MEMORANDUM

SUBJECT: Site Plan Approval – 514, 528 and 540 State Street

DATE: December 29, 2022

Request: Site Plan Approval for the construction of a 2,738 sq. ft. Taco Bell restaurant and associated site improvements at 514, 528 and 540 State Street, Parcel Numbers 12-03-126.000, 12-03-127.000 and 12-03-128.000

Truck Turning Movements	
Drawing Name:	
Date:	10/12/22
Type:	LG 50
Drawn By:	SLA
Scale:	1" = 20'
Project No.	22-0408
	TT1
Drawing No.

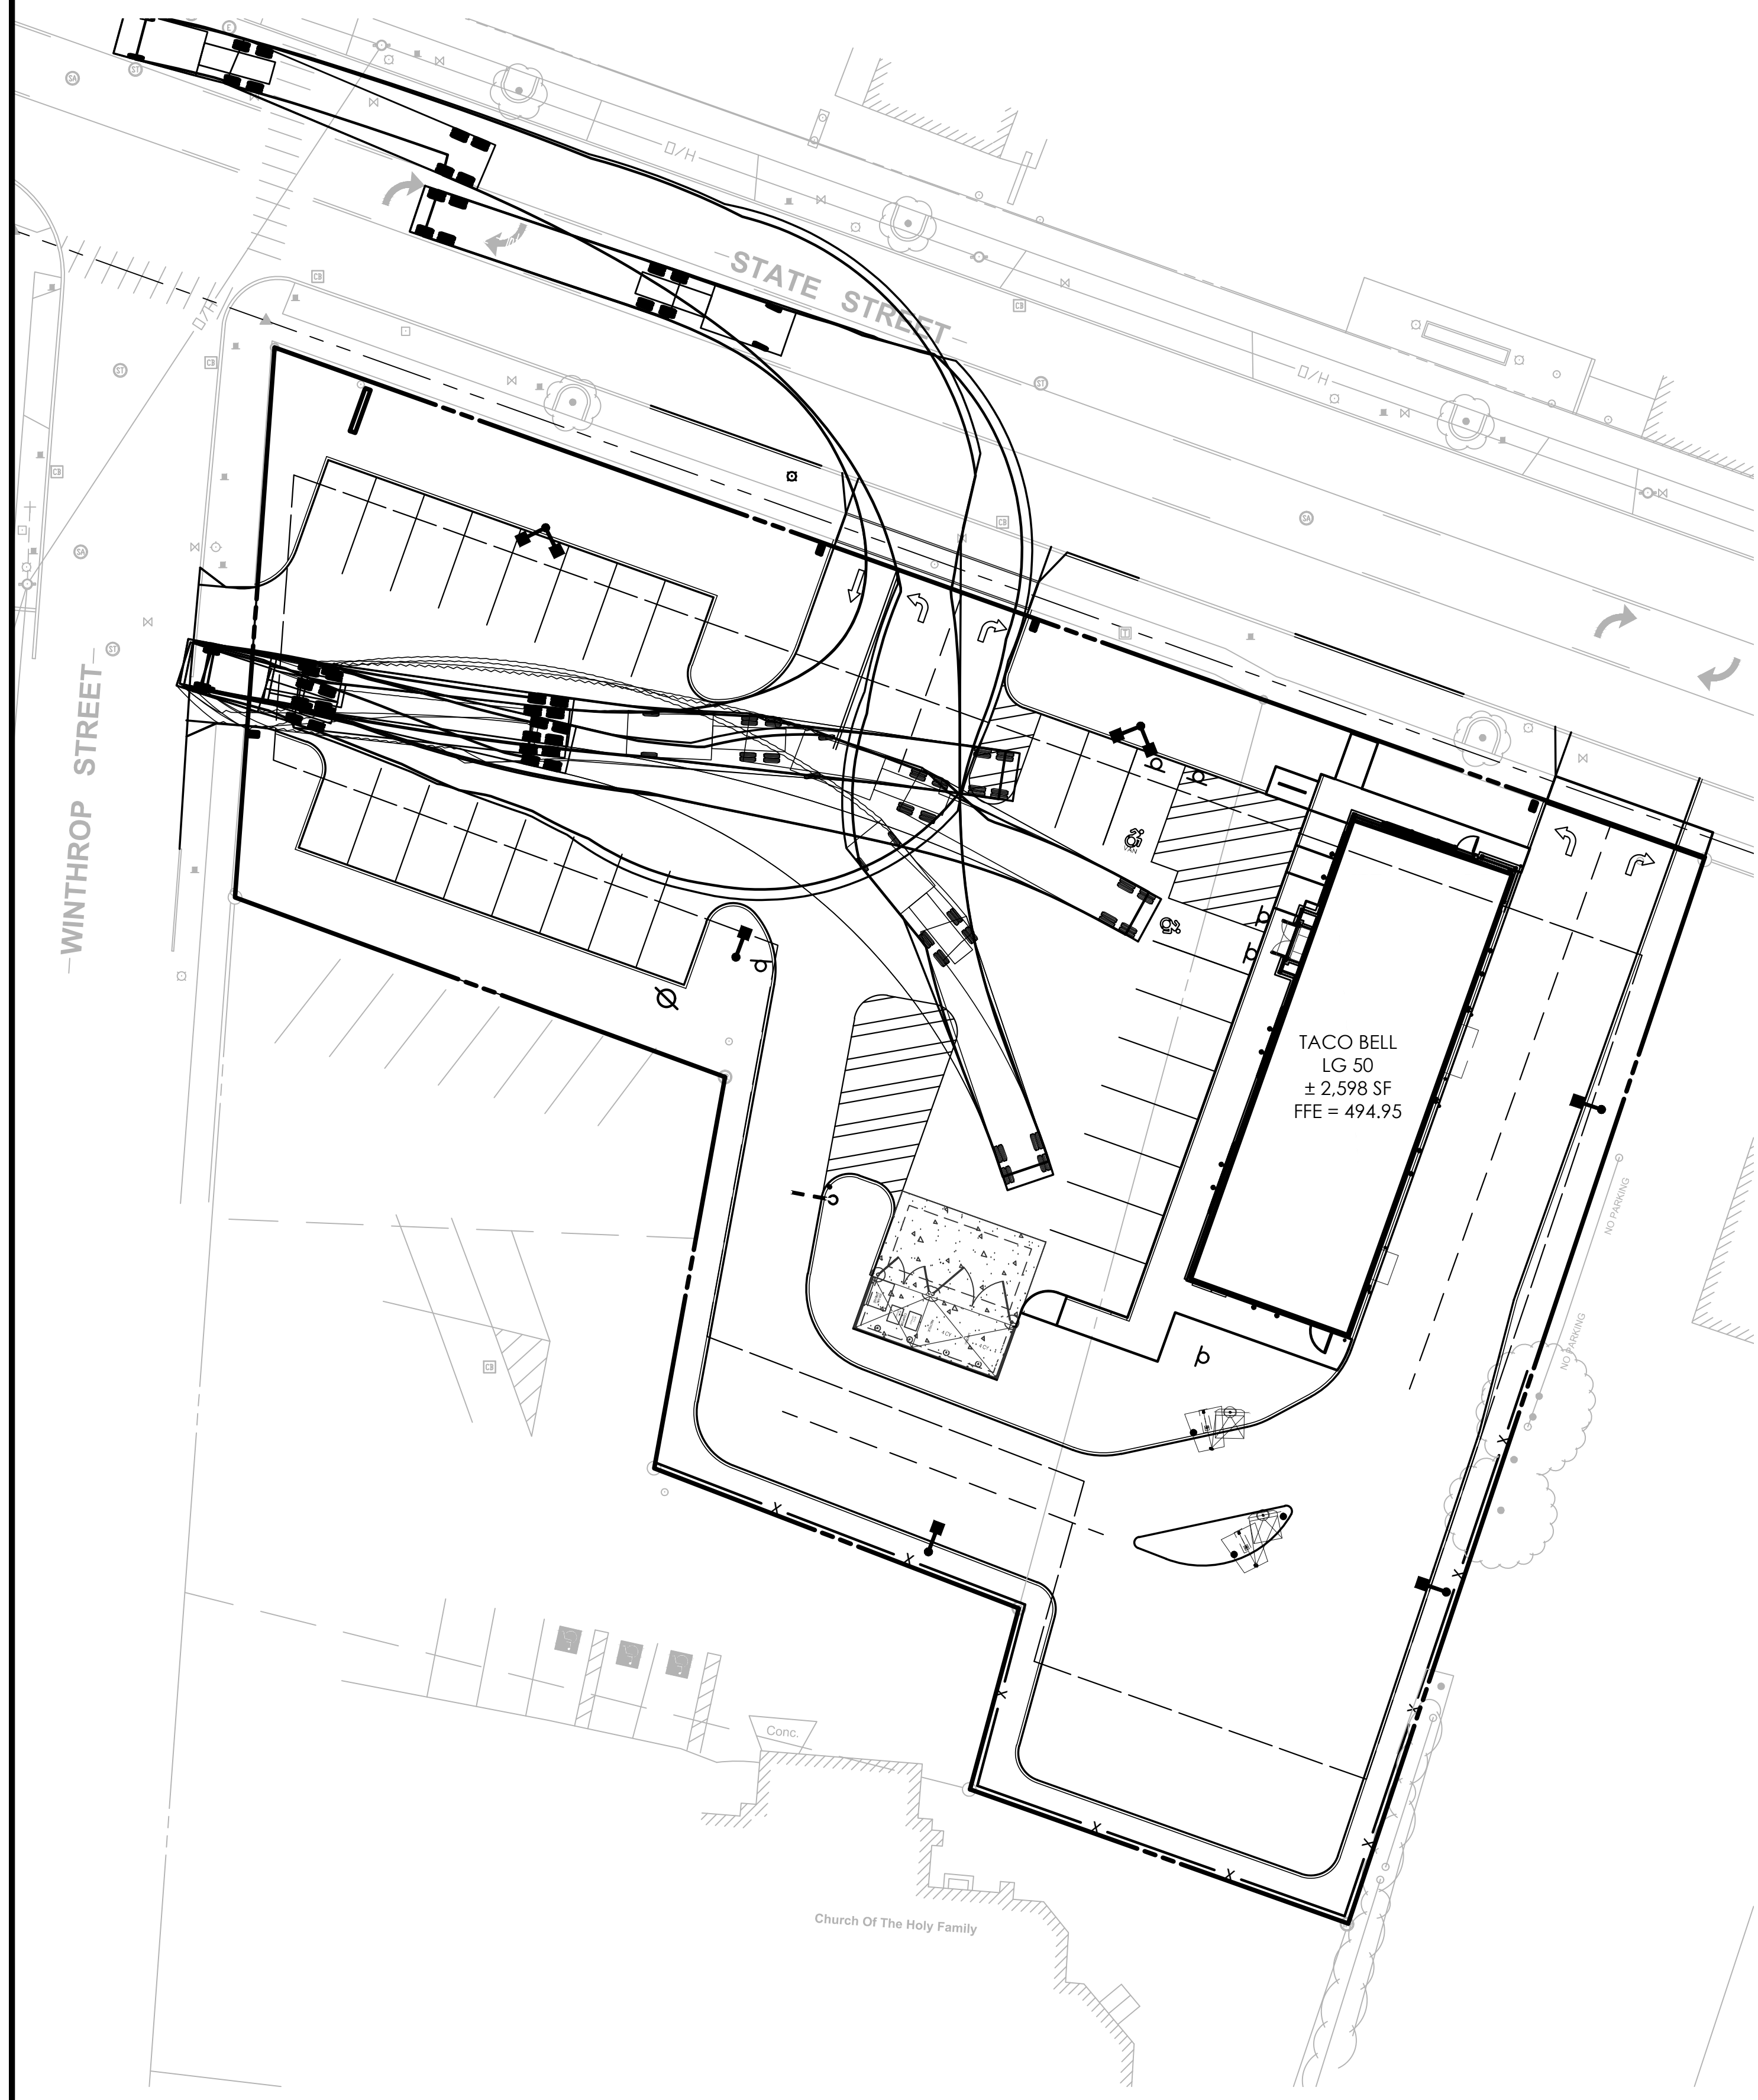
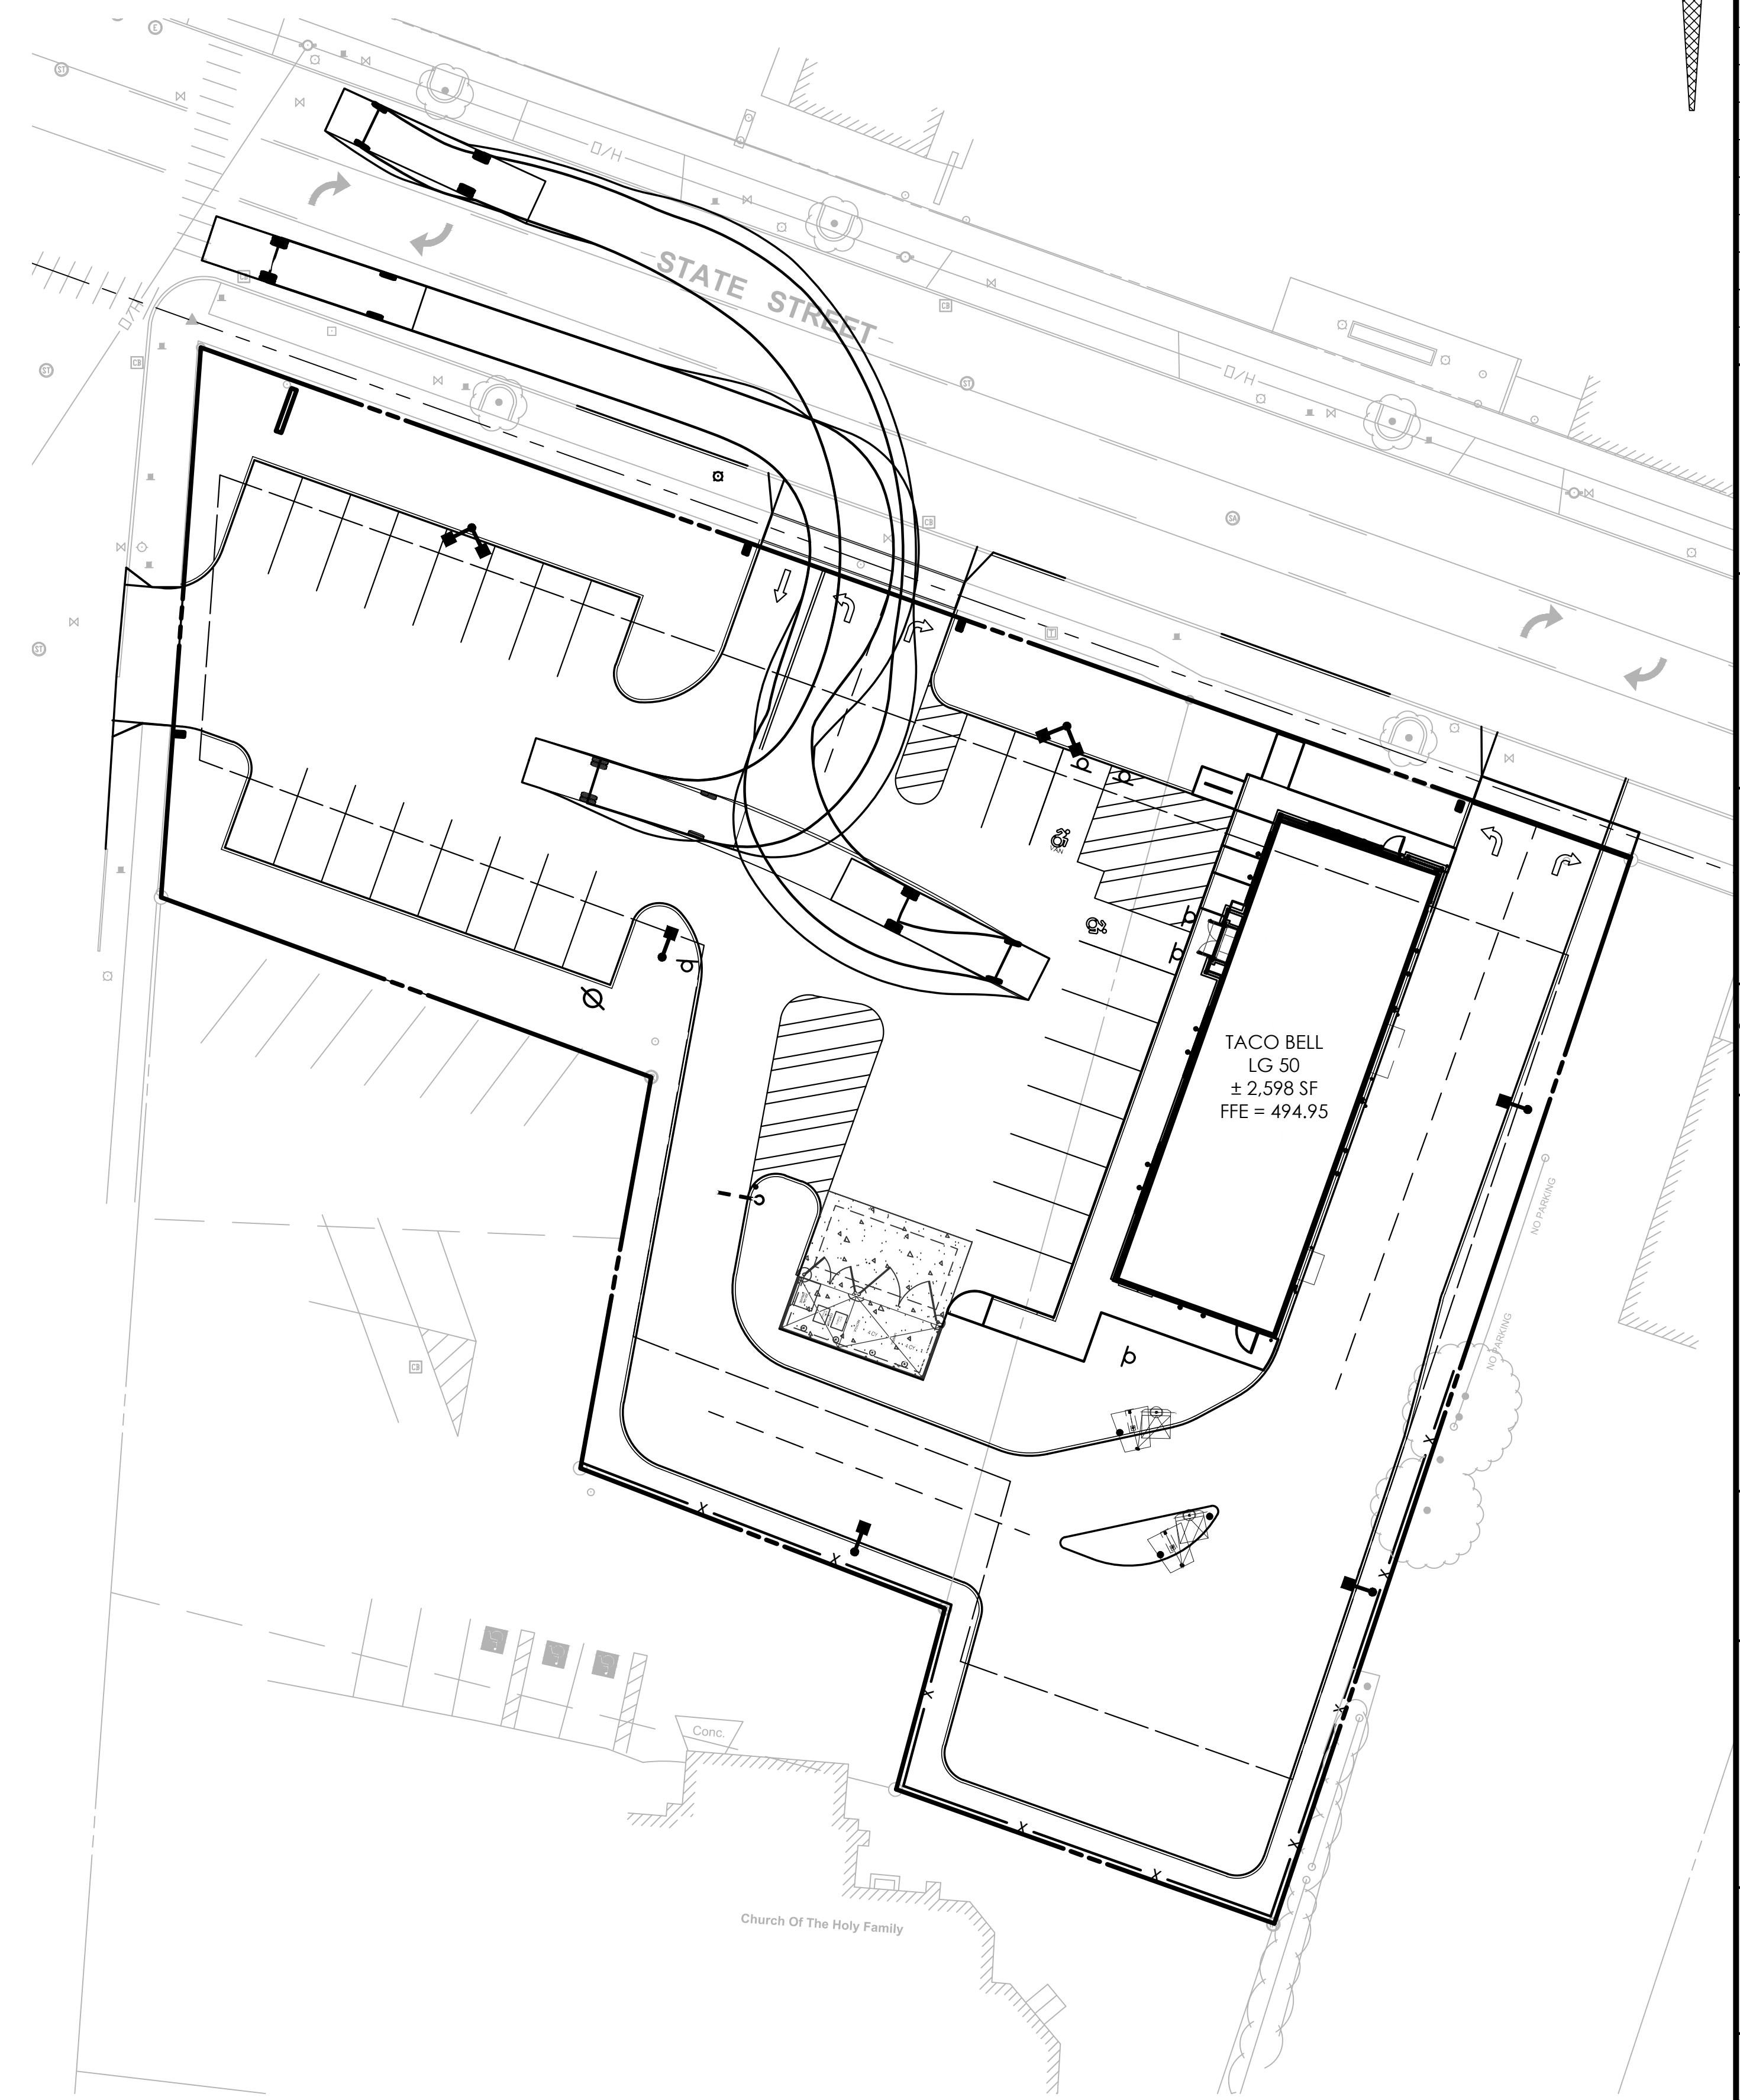
A truck turning movement plan has been included in the submission packet. The plan shows that both delivery trucks and fire trucks will access the site from the main entrance on State Street. The circulation of the site is not ideal for these types of large vehicles, so the trucks will need to do a three-point turn in order to exit the site. This could be problematic if customers are trying to access the site during the same time as a large delivery truck is on site. The applicant should discuss whether deliveries are completed outside of normal operating hours or during business hours.

LIGHTING PROPOSAL		LO-157120-1	
TACO BELL STATE STREET WATERLOO, NY			
BY:GAM	DATE:12/19/22	REV:12/19/22	SHEET OF 1
SCALE: 1"=16'		0 16

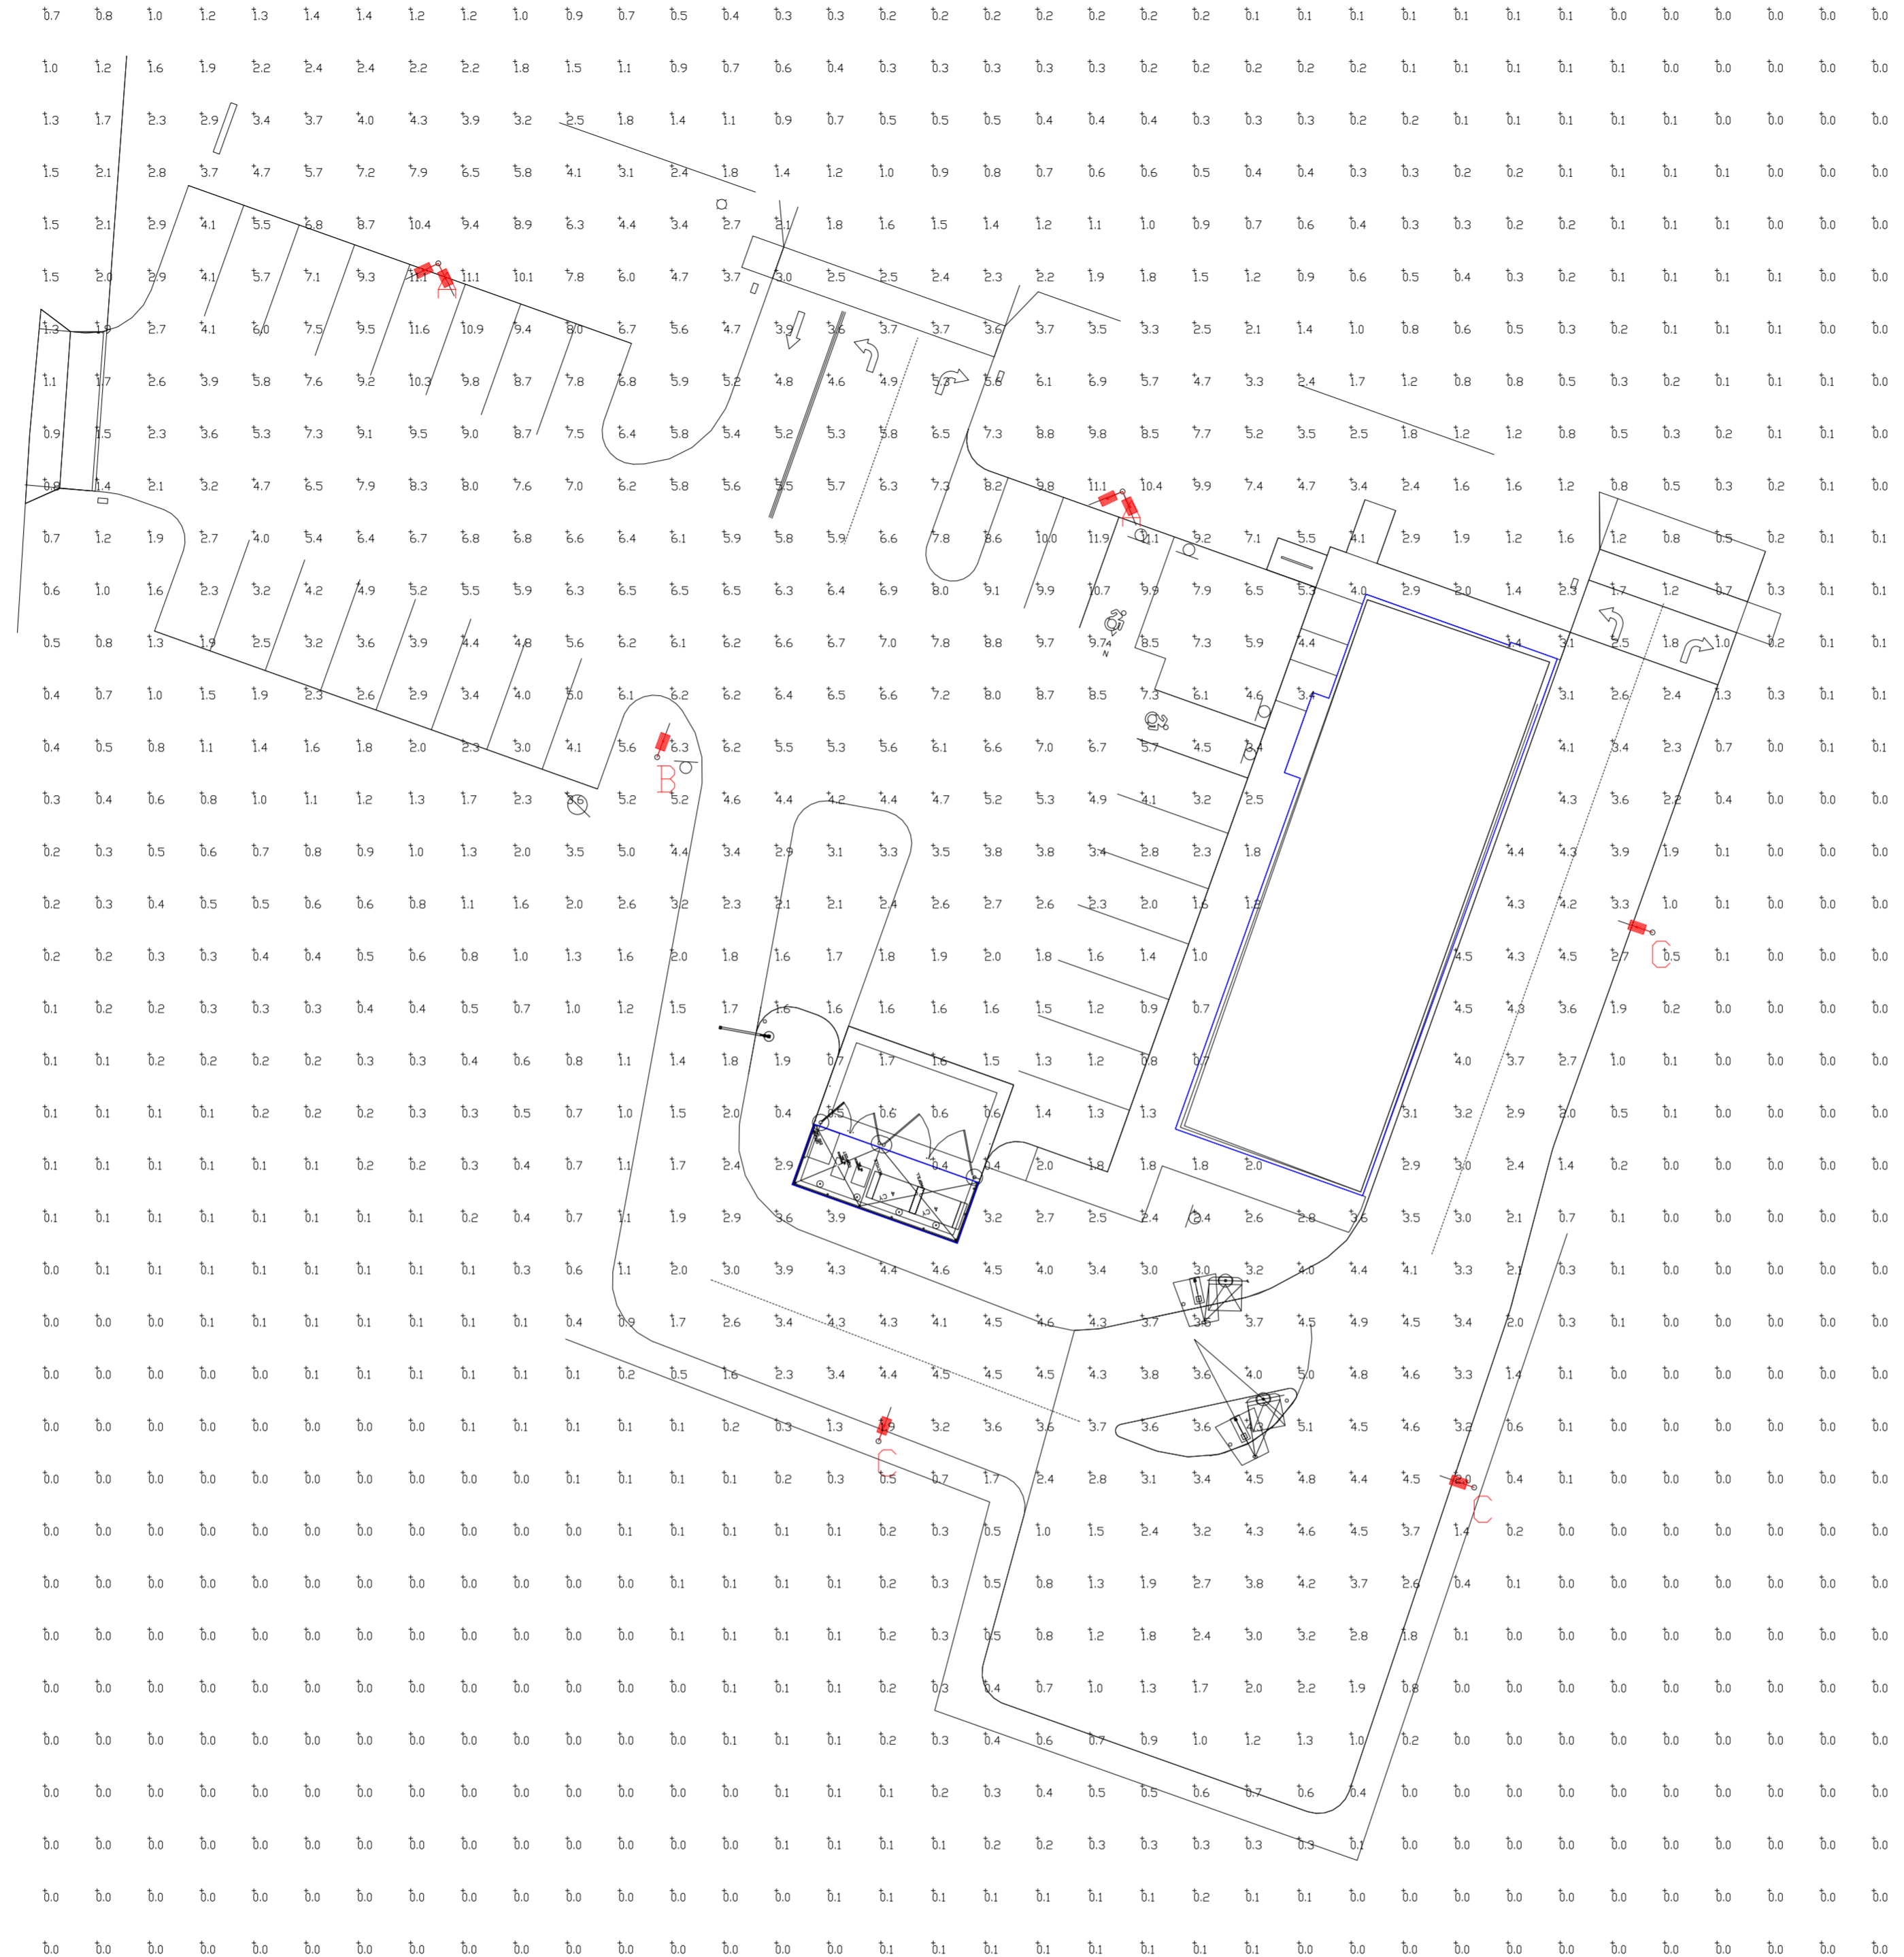
Lighting: The photometric plan submitted shows a significant amount of light spillage onto the church property to the rear. This light spillage is the result of a flood light on an existing utility pole at the rear of the site, directing light to the church parking lot. The applicant is proposing to remove this pole as part of the project. The applicant will work with the church to replace the light in order to provide lighting for their parking lot.
